UNITED STATES PATENT AND TRADEMARK OFFICE

10/750,698

Office Action Summary	Application No. 10/750,698	Applicant(s) COTTRELL ET AL.	
	Examiner Joseph F. Edell	Art Unit 3636

DETAILED ACTION

Diagram A - Annotated Figure 3 of Jost

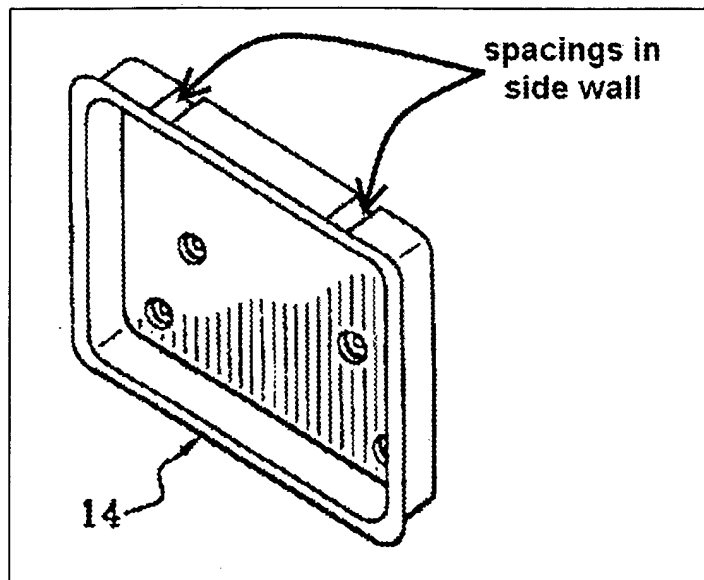
Jost discloses a vehicle mounted peripheral device station that is basically the same as that recited in claims 1-9, 11-13, 15-27, 29-31, and 33-36 except that the specified means for securing is not taught, as recited in the claims. See Figures 1-6 of Jost for the teaching that the vehicle mounted peripheral device station has a vehicle

seat 7 (see Fig. 3) adapted to receive a removable headrest, a peripheral device 8 (see Fig. 2), an adaptor 12, 14, and a means for securing the peripheral device to the adaptor being clamping of the peripheral device (see column 2, lines 28-31), a support surface 14 attached to the adapter that is a plate with a plurality of edges and a plurality of side walls to frictionally receive the peripheral device, the plurality of side walls including a front wall, a first side wall, a second side wall, and a non continuous back wall, first and second receptacles 20, 20 in the seat to receive first and second posts 6, 6 of the adaptor wherein at least one of the post is adjustable to modify the distance between the post, and at least one post is capable of vertical pivoting about an axis formed along sleeve 19. See Diagram A below showing that at least one of the plurality of side walls of Jost is noncontinuous and by portions of the front wall being removed the overall height of the wall is reduced.

Merritt shows a vehicle mounted peripheral device station similar to Jost wherein the adaptor 1, 13 (see Fig. 1) and peripheral device 2 are secured via hook and loop fasteners. Therefore, it would have been obvious to one having ordinary skill in the art at the time the invention was made to modify the station of Jost such that the means for securing the peripheral device to the adaptor is hook and loop fasteners, such as the station disclosed by Merritt. One would have been motivated to make such a modification in view of the suggestion generally available to one of ordinary skill in the art that hook and loop fasteners are inexpensive fasteners that allow the two structural piece to be repeatedly attached and detached from one another.
